SIB 34 02 24

RECALL 24V-104: INTEGRATED BRAKING SYSTEM

2025-10-31

This Service Information Bulletin (Revision 15) replaces SI B34 02 24 **dated August 2025**.

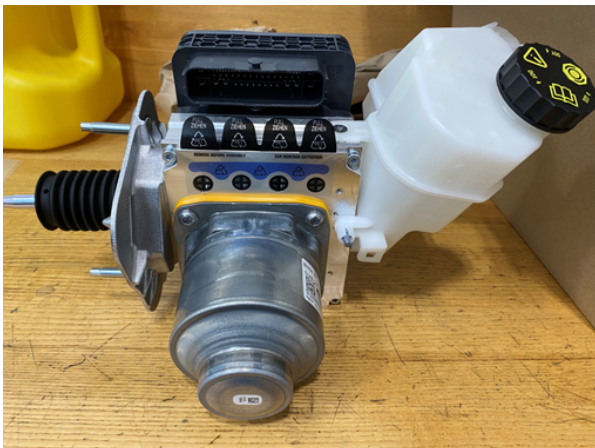
Replace the IB with either a “wet” pre-filled unit or a “dry” unfilled unit.

“Wet” IB pre-filled: Brake fluid reservoir is filled (arrow) and brake fluid line ports are plugged with bolts (circled).

“Dry” IB unfilled: Brake fluid reservoir is empty; brake fluid line ports are sealed with labels.

5B67B85
5B6E463
5B6E465
5B6E467
5B69D61
5B69D63
5B69D65
5B72715
5B72716
5B6F947
5B6F943
5B77C55
5B77C23
5B77C24
5B77C25
5B77C29

5B3C874
5B3C857
5B421D0
5B3C859
5B6C7F1
5B6C7F2
5B6C7F3
5B6C7F5
5B6A736

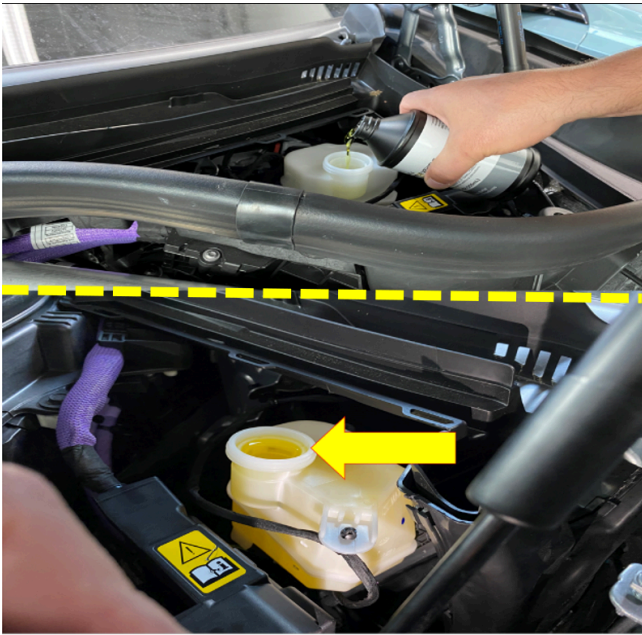
- Prior to installation, the Integrated Brake Modules should be inspected for damage upon arrival. Light scratches are acceptable, but if the aluminum cover is dented or bent, ~~if damage is found~~, please send photos in a Recall IDS Ticket for review prior to entering a claim. If approved, please claim in accordance with the Dealer Services Return and Claims Manual.

Do not install any part which shows visual damage as shown, or has been dropped from any height.
